The Corporation of the District of West Vancouver

Board of Variance Hearing Agenda

May 20, 2026

Figure 1
Existing as-built roof assembly (left), assembly listed in Building permit drawings (right).

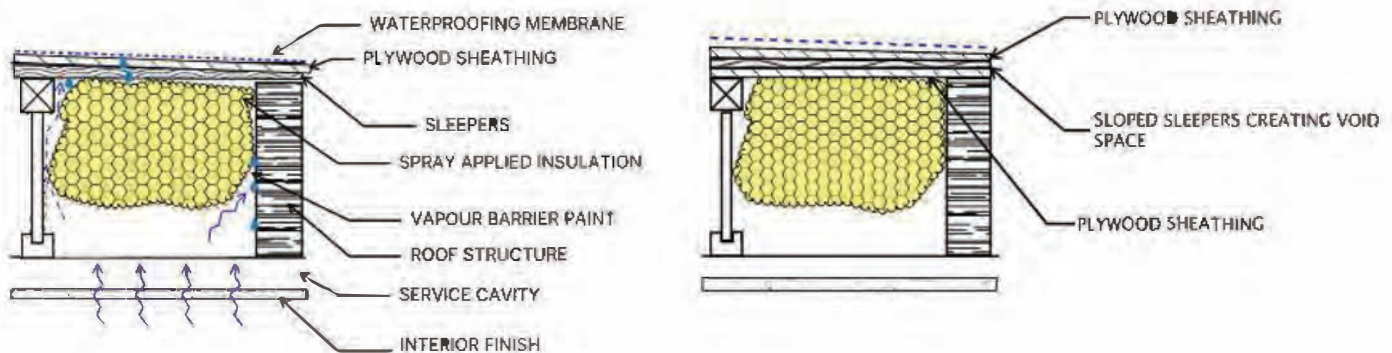
- The existing roof assembly consists of plywood sheathing, sprayfoam insulation, a service cavity, and interior framing (Figure 1, left).

- As the plywood sheathing is fully exposed to exterior air temperatures and subject to night sky radiation, should air leakage occur there is risk for condensation on the underside of the plywood sheathing (as also shown in Figure 1).

- The building permit drawings (only drawings determined to be available) indicated a cavity (utilizing two layers of sheathing) that may have provided some level of venting or drying potential of the sheathing.

- The as-built condition did not meet this (Figure 1, right).

Figure 2
Moisture risk for assembly from guide.

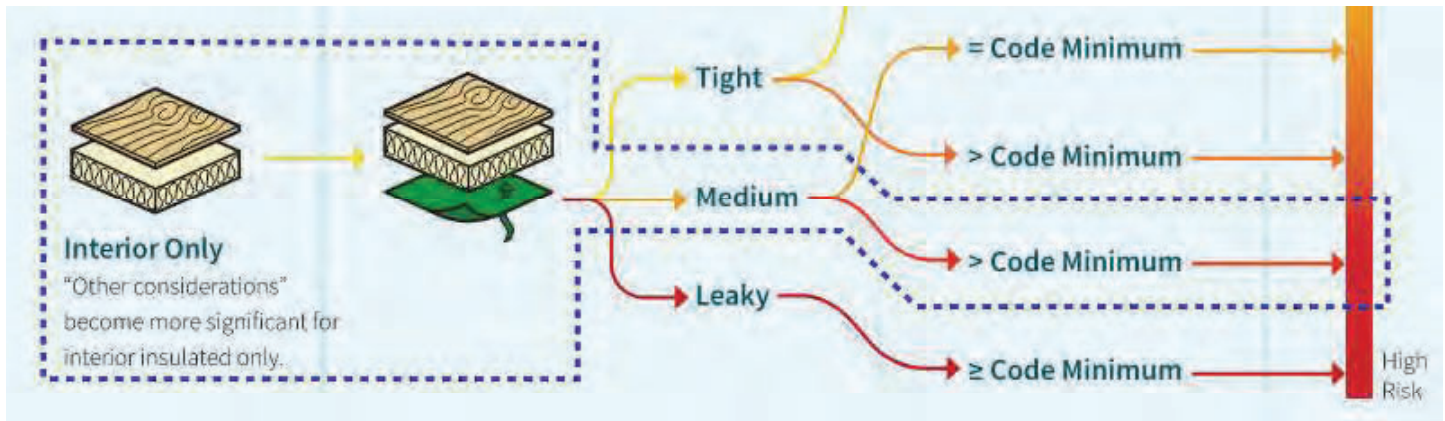
- The current design and building height do not include a strategy for venting or mitigating air leakage into the roof assembly.

- The existing parapets heights, even at the current condition with interior insulation, do not meet best practices for parapet heights (RCABC Best Practice guide).
- Achieving a continuous air and vapour barrier tie-in from the existing wall areas to the new roof assembly is challenging and can likely only result in moderate air tightness.
 - The more interior air leakage that occurs, the greater the risk of a vented low-sloped wood roof assembly.
- To retroactively modify the existing roof to allow for venting with interior insulation only will require significant reframing, unavoidable parapet height increase, yet still result in a moderate or high-risk roof assembly as categorized in the best practise guide.

Figure 3
Sketch of proposed roof assembly

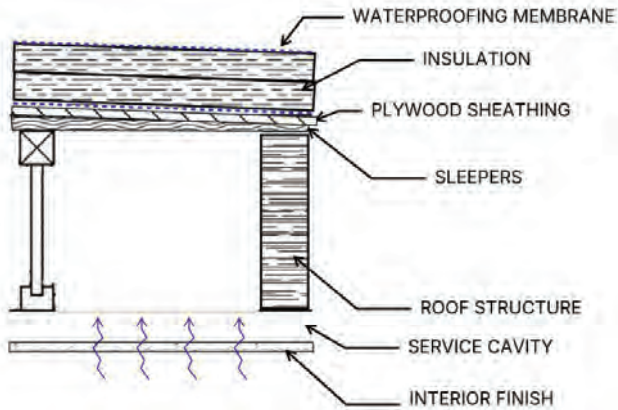
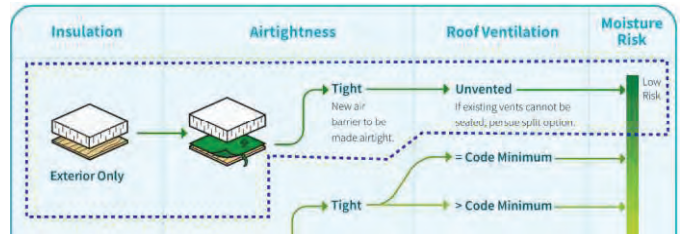
To reduce the risk of condensation and work with the existing framing (not designed for venting) RDH recommends a conventional roof with the insulation installed on the top of the roof sheathing (Figure 3).

- This assembly is consistent with current practises used today in retrofits and new construction due to the decreased moisture related risks.
- As the structure remains on the warm side of the insulation, the structure can naturally continue to dry out.
- Lastly as a added benefit, the building will be able to be designed with a continuous exterior air barrier and insulation leading to improved air tightness and thermal performance recuding green house gas emissions from lower heating and cooling loads.
